Scope of the revision

29th Floor - M-529 SD R2: Bubbled Areas

30th Floor - M-530 SD R2: Scope and Quantities

31st Floor - M-531 SD R2: Scope and Quantities

31-5

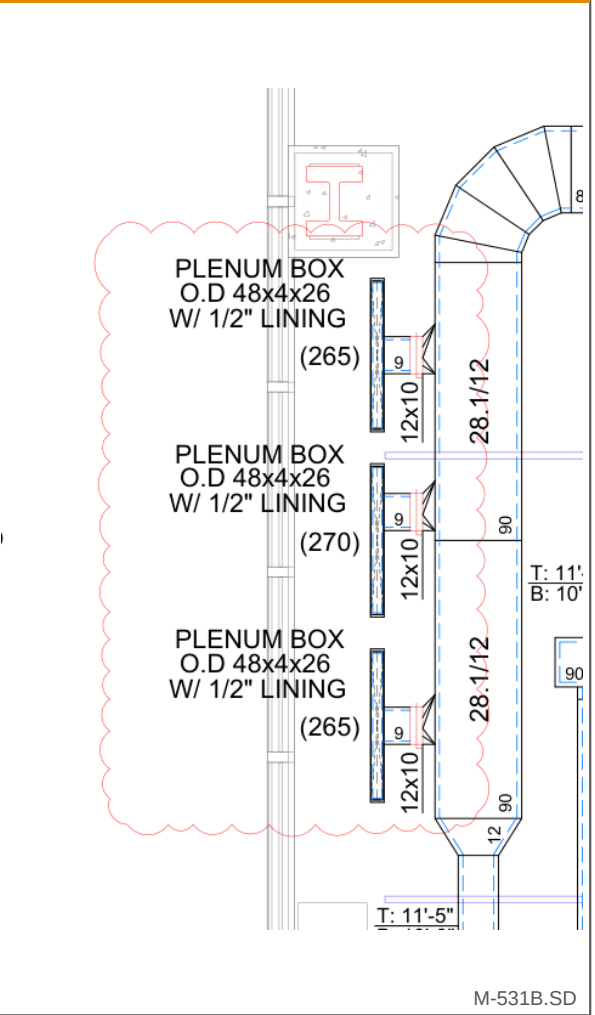
3 x LD | 800 CFM

31-6

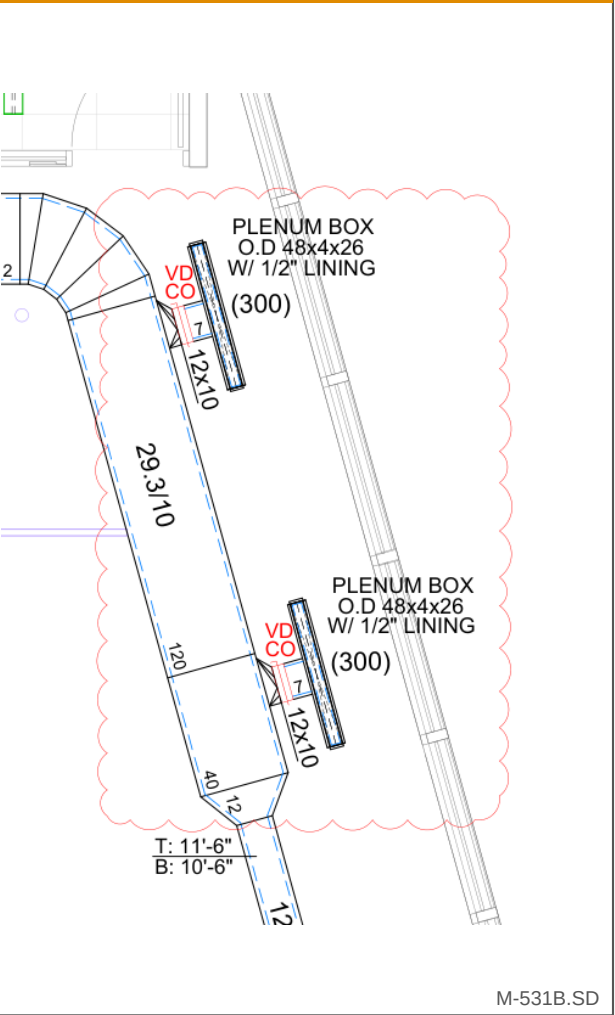
2 x LD | 600 CFM
